**OHIO TURNPIKE AND  
INFRASTRUCTURE COMMISSION**

**ADDENDUM NO. 3**  
**ISSUED: APRIL 22, 2021**

**PROJECT NO. 58-21-03**

**PART A: TOLL PLAZA 64 EXPANSION PLANS, MILEPOST 64.9, WOOD COUNTY, OHIO**  
**PART B: TOLL PLAZA 152.2 EXPANSION PLANS, MILEPOST 152.2, LORAIN COUNTY, OHIO**  
**ISSUED: APRIL 7, 2021**

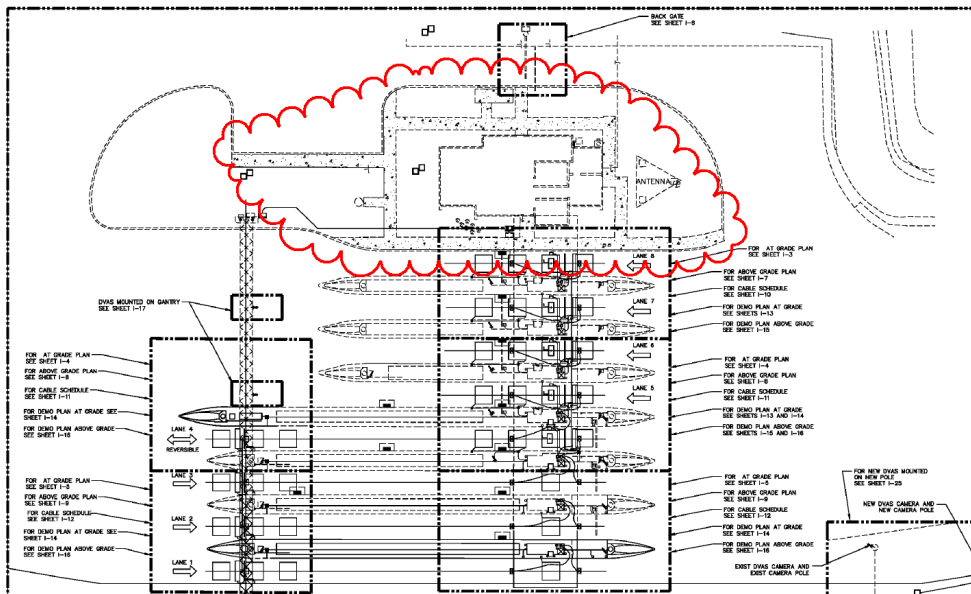
**Q#6 Is the rebar in the toll island epoxy coated?**

*A#6 In accordance with the requirements of Special Provision SP 509, Plan Sheet A39 Note 2, and Plan Sheet B35 Note 2, all reinforcing steel shall be epoxy coated.*

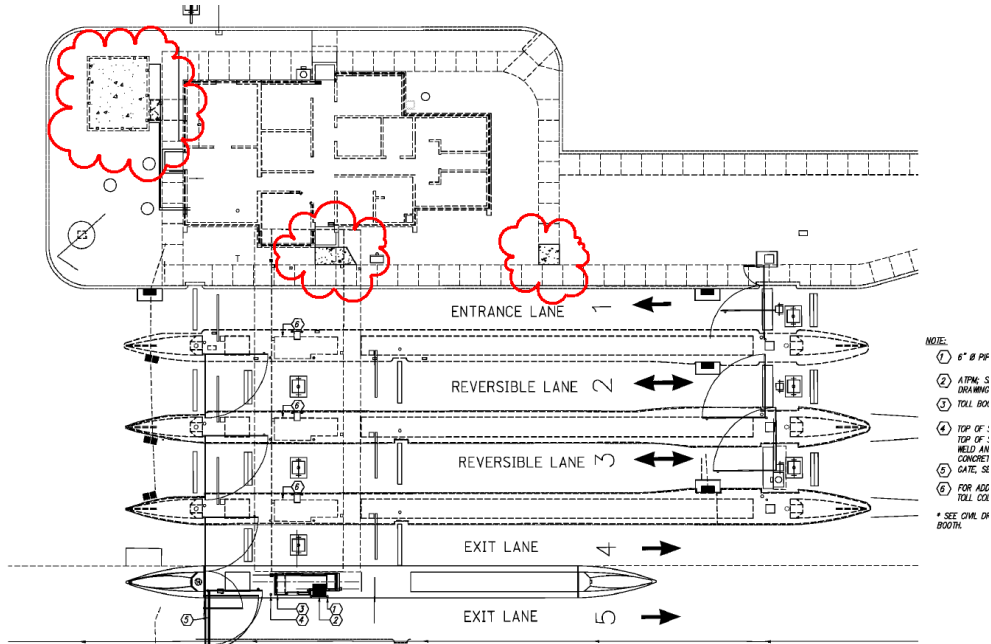
**Q#8 Are these sidewalks new and a part of this project? If so, is there a detail for sidewalk?**

A#8 *The sidewalk removal and replacement limits are shown on Plan Sheet A20 (C-11) for Toll Plaza 64 and Plan Sheet B18 (C-9) for Toll Plaza 152. It is not anticipated to remove and replace any sidewalk beyond what is shown on the referenced sheets.*
